**SAN ANTONIO WATER SYSTEM  
Interdepartment Correspondence Sheet**

**Subject:** Zoning Case Z2023-10700044 (Moonlight Way Townhomes)

**Date:** April 7, 2023

ZONING CASE: MOONLIGHT WAY TOWNHOMES (FIGURE 2)  
ZONING FILE: Z2023-10700044

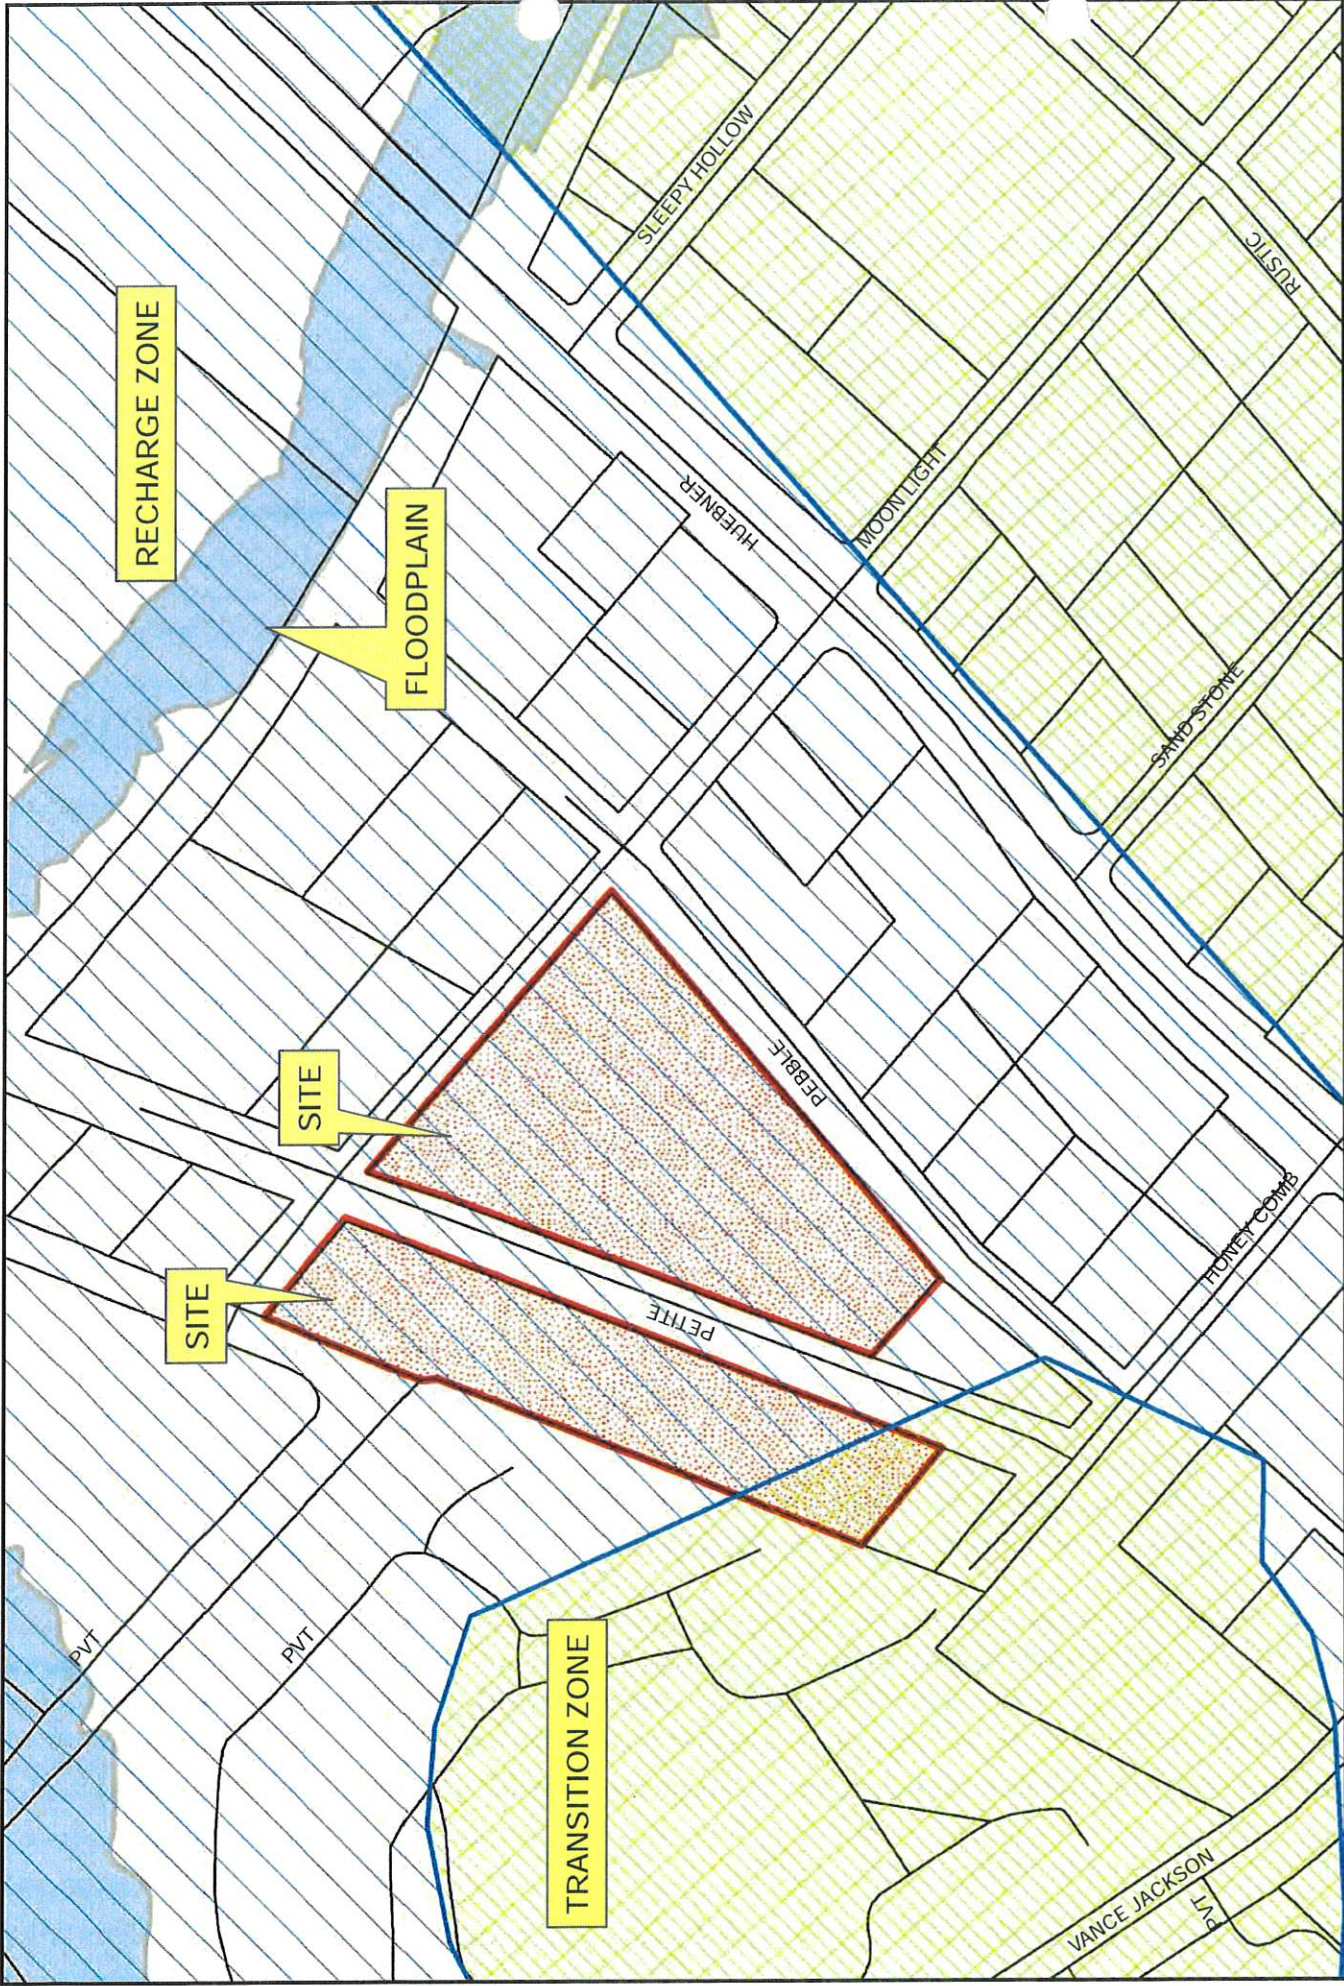
The subject property is within City Council District 8, approximately 0.85-miles east of Huebner Rd. and IH-10 West intersection. A portion of the property, 5.67-acres lies within the Edwards Aquifer Recharge Zone and the remaining 0.33-acres lies in the Transition Zone (Figures 1 and 2).

1. The impervious cover shall not exceed 50% on the approximately 5.67-acre portion of the site in the Edwards Aquifer Recharge Zone.
2. The land uses within the project site shall be in conformance with the table of permitted uses at the time the re-zoning is approved. Should a proposed use be listed as requiring City Council approval, the owner/operator shall apply for re-zoning for that particular use at the project site. If the land use is listed as special use, a special permit must be obtained for that use. If the land use is listed as not allowed, that land use will not be permitted on the project site.
